CABINET MEMBER FOR ENVIRONMENT – 16 JULY 2020
OXFORD: CENTRAL AREA – PROPOSED ADDITIONAL CYCLE
PARKING PLACES

Report by Interim Director of Community Operations

1. The Cabinet Member for the Environment is RECOMMENDED to approve proposed additional cycle parking places in central Oxford on New Road, Speedwell Street, Wellington Square and Ship Street.

3. This report presents responses received to a statutory consultation to introduce additional cycle parking places in Oxford city centre at New Road, Queen Street, Ship Street, Speedwell Street, Turl Street and Wellington Square.

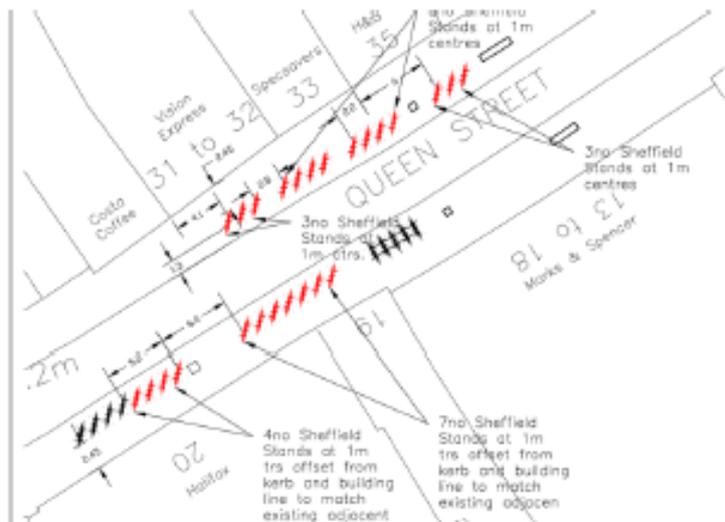
- 17 x round topped black Sheffield stands on frontage of Nuffield College installed perpendicular to the building wall.
- Correctly installed and spaced.

In this context it is of concern that the PTB Spreadsheet recommendation is to "Replace current arrangement with row of 15 x stainless steel Sheffield stands at a 45-degree angle to wall". Cyclox sees no merit in replacing an adequate arrangement with a stainless-steel and inadequate arrangement.

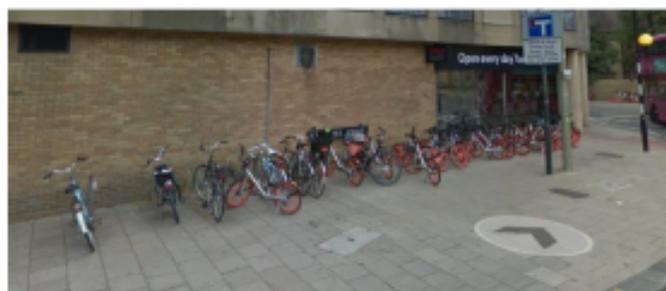
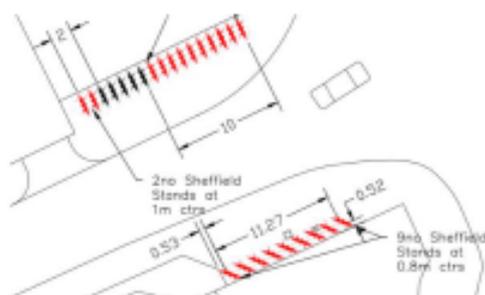
2) Cyclox proposes that the recommendations in the 2018 document are adhered to. In particular Cyclox notes that the 'Oxford City Centre Cycle Parking Audit, 2018', offers this description:

- 15 x stainless steel Sheffield stands installed perpendicular to the kerb on the southern side of the road, to the left of the entrance to Jesus College.
- Correctly installed and spaced.

- Extend row to east and install 10 x Sheffield stands perpendicular to kerb as indicated below.

(e) Turl St additional spaces

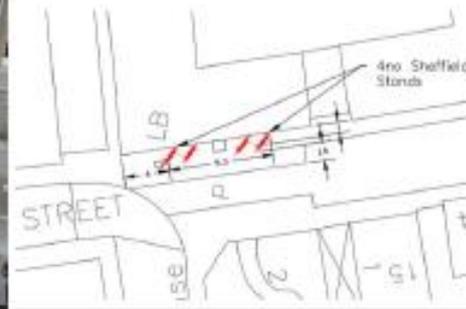
The current usage is to lean bikes against the wall, this is a preferred means for many people who cycle and the biggest improvement would be a bar, or hoops mounted on the wall or adjacent to it (or Copenhagen 'pull-up' locking points), and this is good for non-standard bicycles. There is one on Streetview for 2016, a four-seater:

Few of the proposed spaces would accommodate such a bike.
